SUBJECT: Provides response to request for addl info re main stream isolation valve/alternate leakage treatment sys. *see Reports*

**SUSQUEHANNA STEAM ELECTRIC STATION
MAIN STEAM ISOLATION VALVE/ALTERNATE
LEAKAGE TREATMENT SYSTEM : FOLLOW-UP RESPONSE
TO REQUEST FOR ADDITIONAL INFORMATION
PLA-4303**

Docket Nos. 50-387
and 50-388

FIGURE 10-1
NORTH-SOUTH SEISMIC MODEL

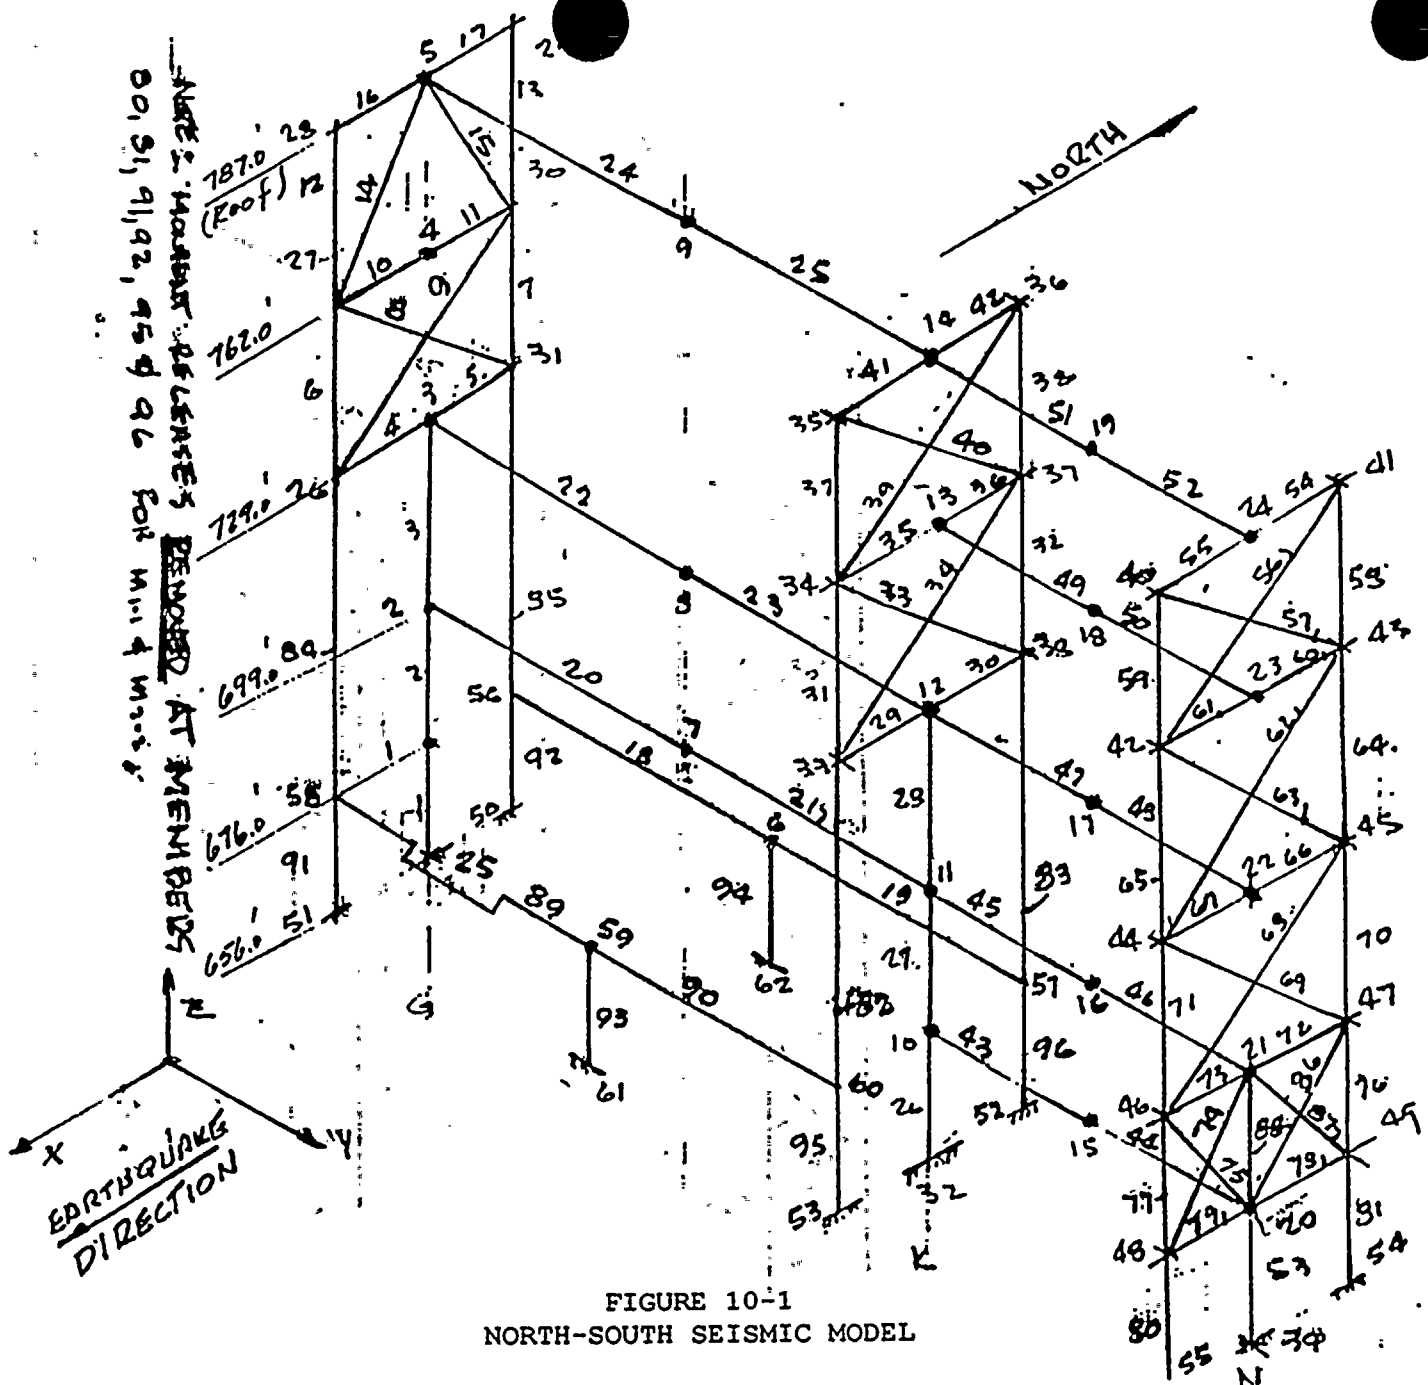
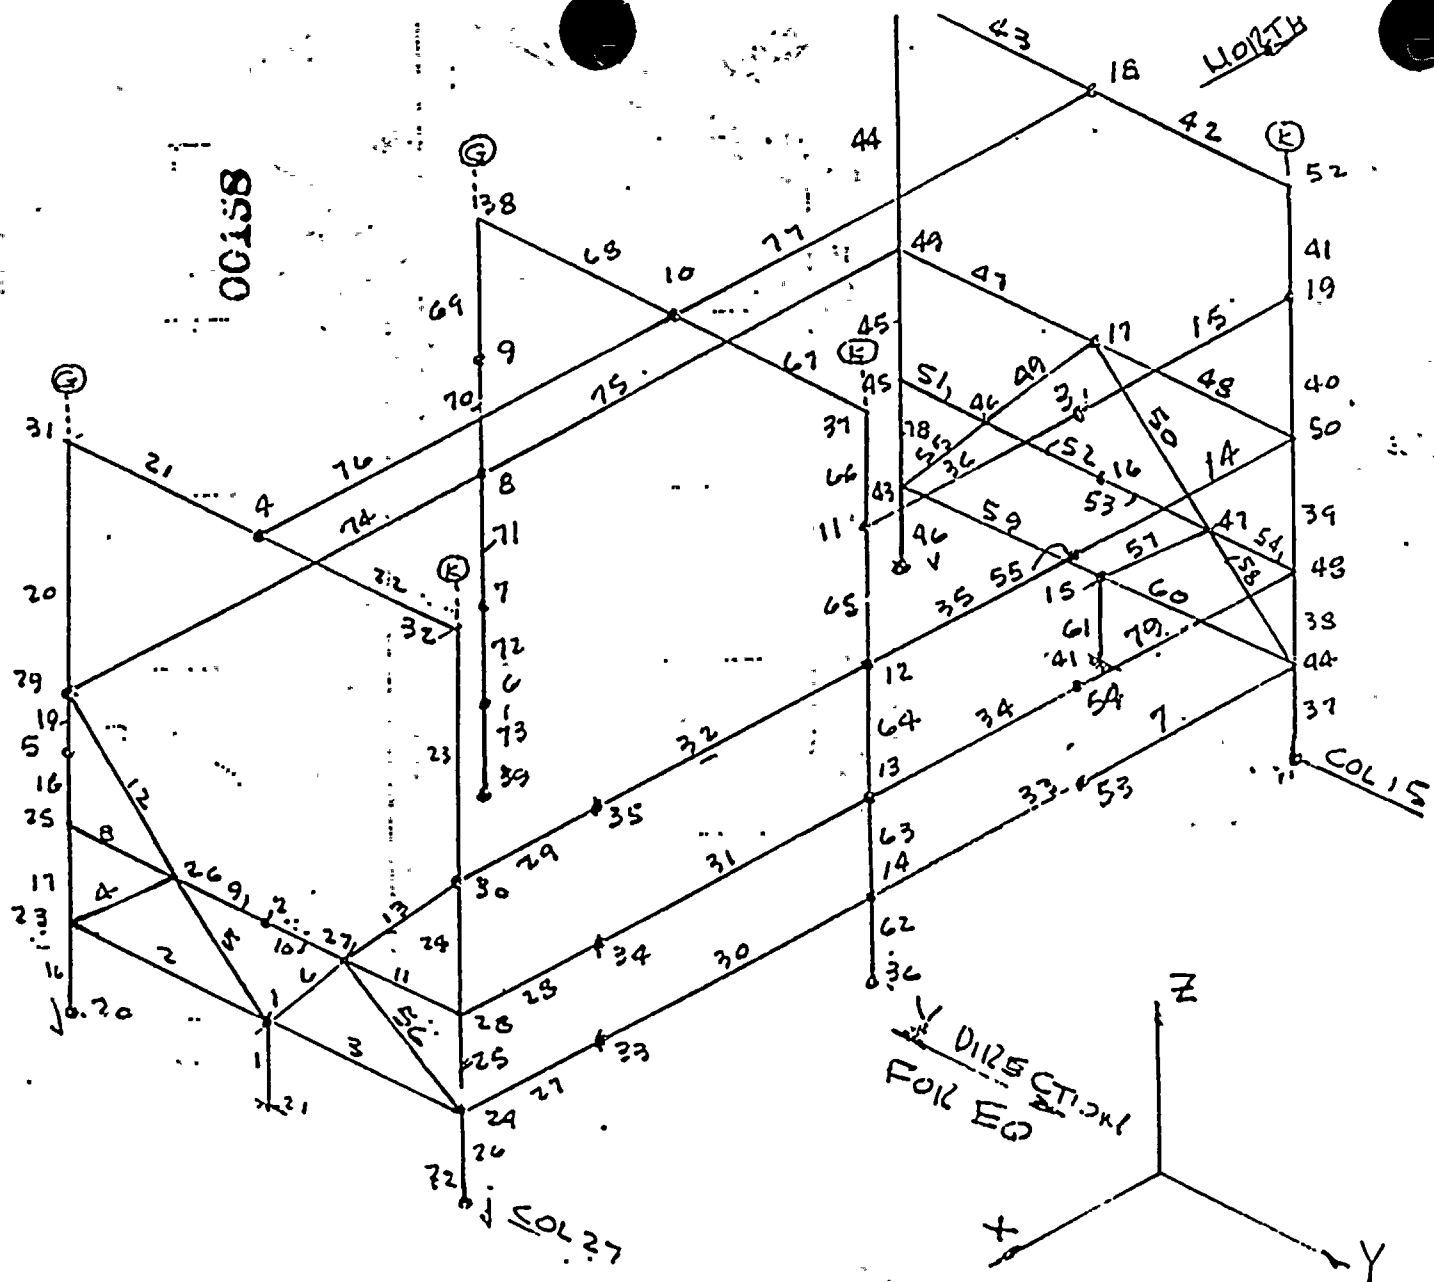
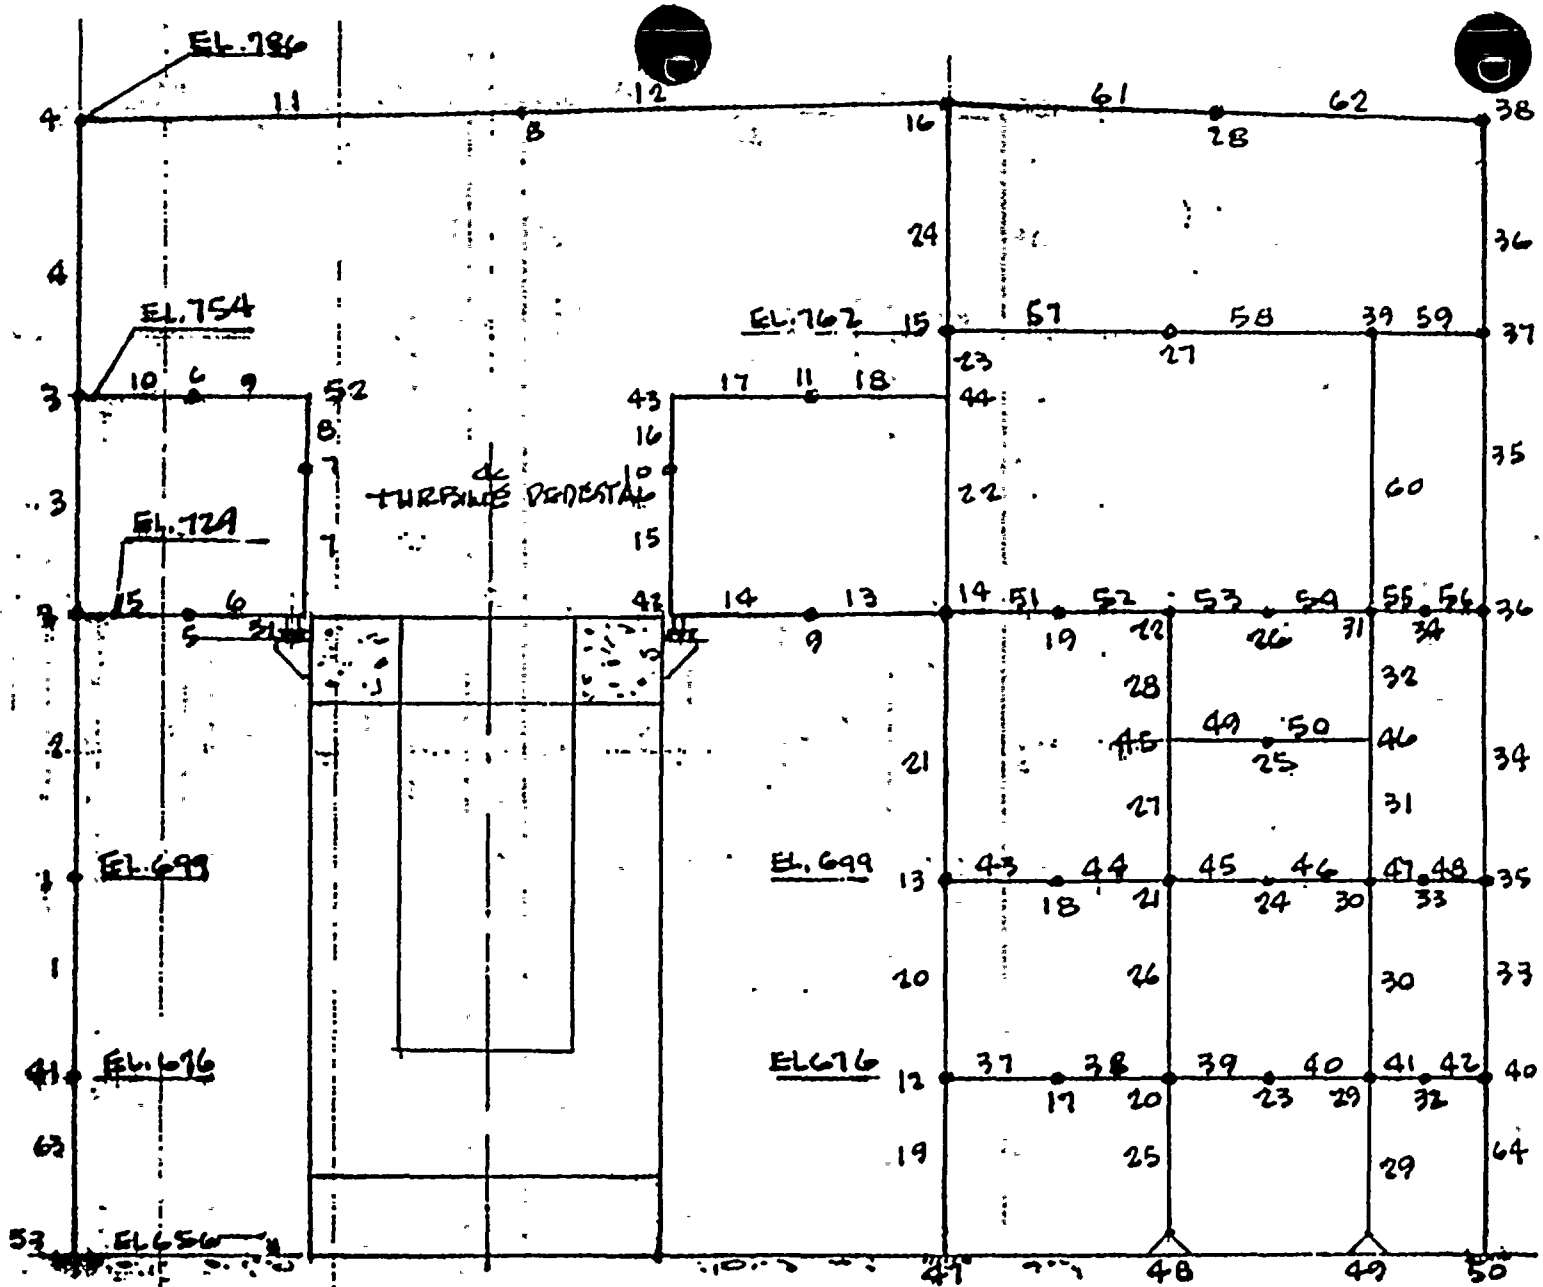
Provide the following information related to the seismic analysis of the turbine building referred to in Section 2.3 (on page 7) of Enclosure 2 of Nov. 21, 1994 submittal:

- a. The details of seismic analysis performed, and the seismic building model that was used, including the structural and soil properties.
- b. A discussion of the procedure used to account for the variabilities associated with the structure frequency, structure damping, and the soil (rock) moduli.
- c. Justification for the use of the NUREG/CR-0098 median ground response spectra as the ground motion input for this analysis.
- d. The location at which the ground motion was input to the seismic building model.
- e. The results of the seismic analysis including the floor response spectra at critical locations of the turbine building.

- 10a. Response spectrum and time history seismic analyses were performed for the turbine building during the original design of the Susquehanna Steam Electric Station. The north-south, east-west, and vertical models are shown in Figures 10 - 1 to 10 - 3. Two east-west models were used for the analysis and design of the turbine building; one model has pinned boundary conditions at the bottom of the columns while the other model has rotational restraints as the boundary conditions at the bottom of the columns. The forces from each of the east-west models were used to obtain the design forces. The SSES design basis earthquake was used as the seismic input motion for analyses. As an example of the models used for analysis, the masses and element beam properties for the north-south model are presented in Tables 10 - 1 and 10 - 2.

Time history analyses utilizing the north-south, east-west, and vertical models were performed in order to calculate response spectra in the respective direction. The structural damping utilized for DBE and OBE is 5% and 2% of critical damping respectively. Response spectra were calculated at those frequencies specified in Table 5-1 of BC-TOP-4A titled "Seismic Analysis of Structures and Equipment for Nuclear Power Plants".

FIGURE 11-1
RIGID FRAME DESIGN MODEL

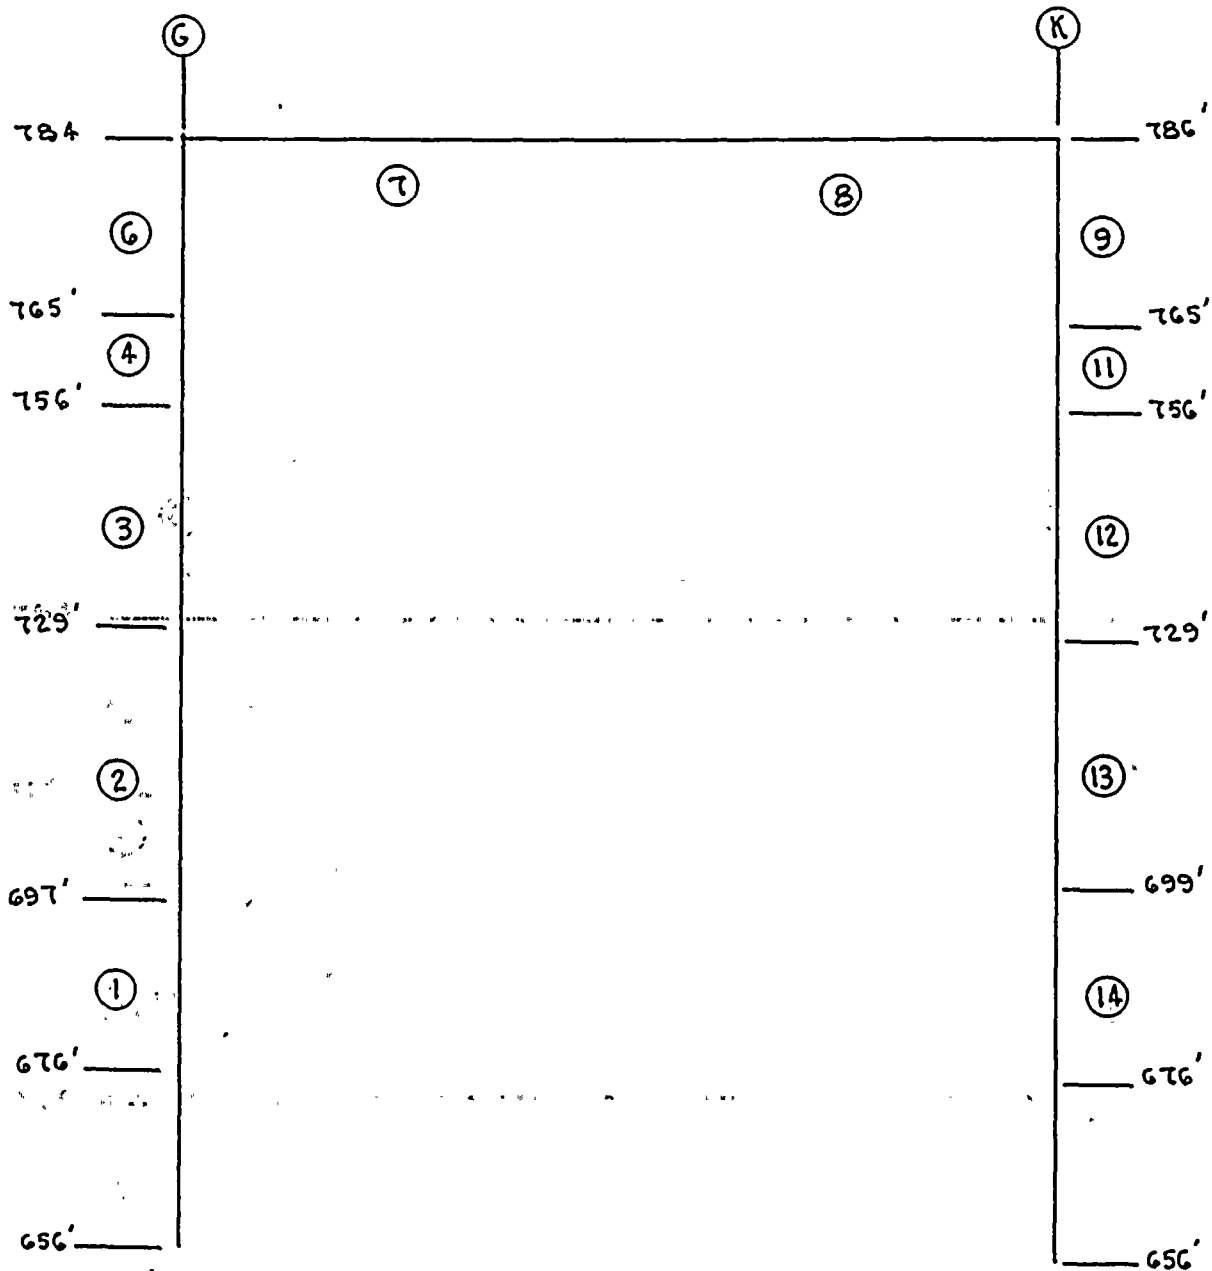
- a. State whether the reported horizontal shears were obtained from the three directional DBE motion input.
- b. The horizontal shears reported in figures 2A and 2B can be considered as seismic demand. Provide the corresponding shear capacity of the turbine building in both horizontal directions.

- c. State whether the analysis results conclude that the turbine building would not collapse during the DBE, and provide technical bases to justify such a conclusion.

For purposes of comparing the seismic demand with the capacity of the structure, it is more appropriate to provide a comparison of the seismic load combination results (DL+LL+Seismic) and the associated interaction ratio for the various components in a typical rigid frame (Figure 11 - 1). Table 11 - 1 summarizes the design forces for rigid frame number 15 along with the acceptance criteria and interaction ratios. This approach is a typical example of the design approach utilized for the turbine building. Based upon the design approach described above, it is concluded that the turbine building design is adequate for the DBE.

- 11c. Since the structural acceptance criteria for steel structures, described in the response to question 11f, is satisfied for the design of the turbine building, it is concluded that the structure will not collapse during the DBE.
- 11d. Deflections at selected locations are presented in the table below for both the east-west and north-south directions.

Figure 12 - 1

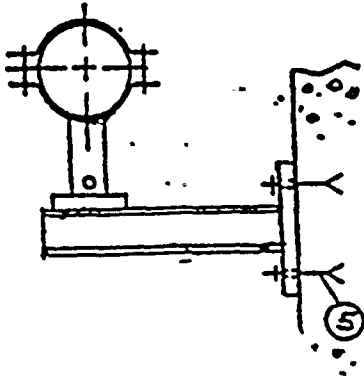
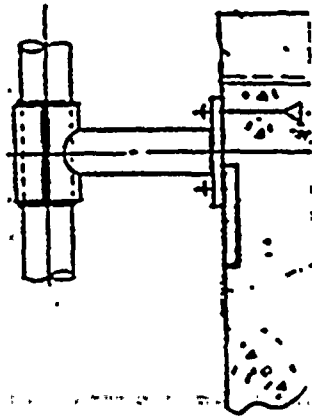
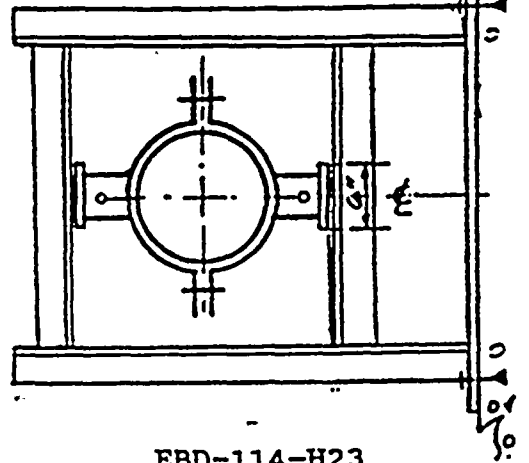
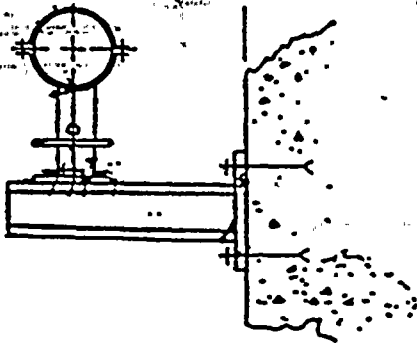
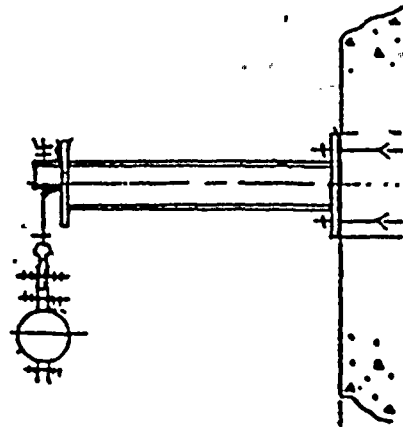
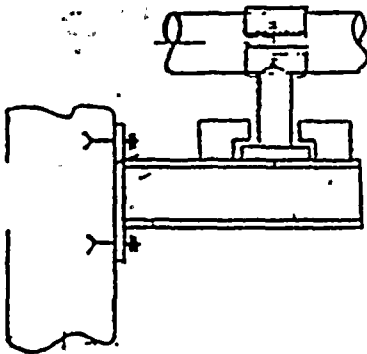
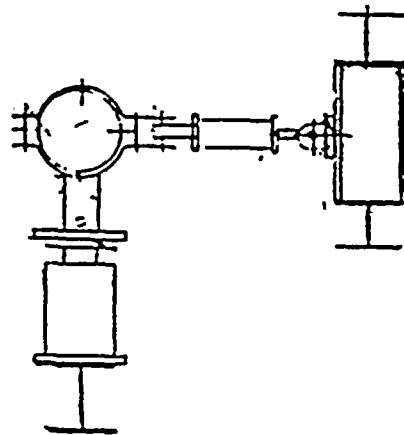
- a. The submittal did not address how the seismic demand for the pipe anchors was obtained, however, during the January 24, 1995 meeting, the licensee stated that the seismic demand was obtained from piping dynamic analyses. Provide information on the type of analysis performed, the basis of acceptance for the analysis procedure, and the results of the analysis.
- b. Provide the evaluation results for piping anchors by comparing the seismic demand to the anchor capacity.

- * This is an anchor which is welded to an embedded plate and it has 3/4" HILTI KWIK bolts. Since piping on one side of the anchor was not analyzed, plastic shear and moment capacity of the pipe were utilized for anchor design. Therefore, the anchor bolts have been designed for the worst possible loading and, consequently, they are judged to be adequate for DBE loading.
- ** Some of the support safety margins are different from the respective margins provided in PLA 4274 as a result of using the higher upset allowables in lieu of the normal allowables and performing more detailed analyses including prying effects. However, the selected 8 pipe supports are still seismically adequate.

In conclusion, the selected pipe support anchor capacities, as well as stresses in support members, welds, and base plates, have been evaluated to determine a margin of safety for each of the selected supports. These safety margins indicate that each of the analyzed supports would not experience any overstress in the event of a design basis seismic event.
